[Issue No.] HIME-T-P-0195A

[Title] Changes in the nameplate and the surface printing according to the compliance with European Consistent Standard EN61010-2-201:2013

[Relevant Models] CL1 series

Ex.) For CL1XY8-DR1B2

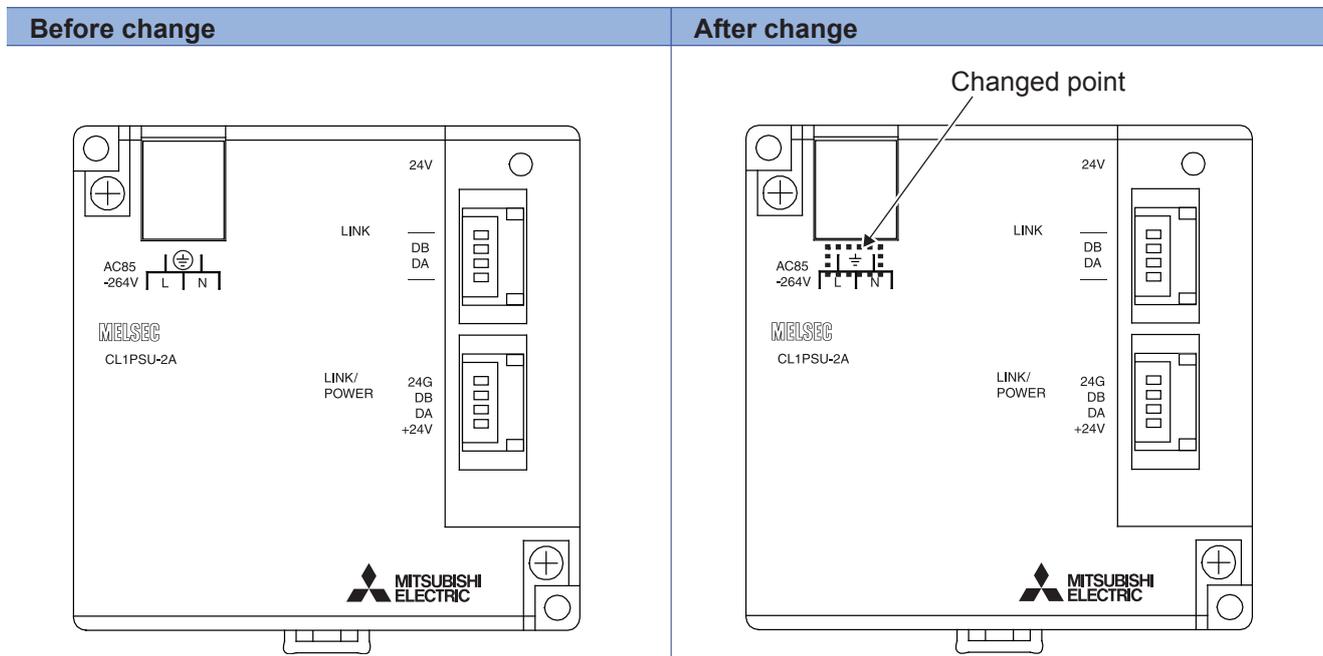
Changed point (1)

⚠ Mark added.

The ⚠ mark on this nameplate indicates the instruction to refer to the manual during installation.

Changed point (2)

Changed the output rated value to the value described in the manual. (Specifications are unchanged from conventional products.)
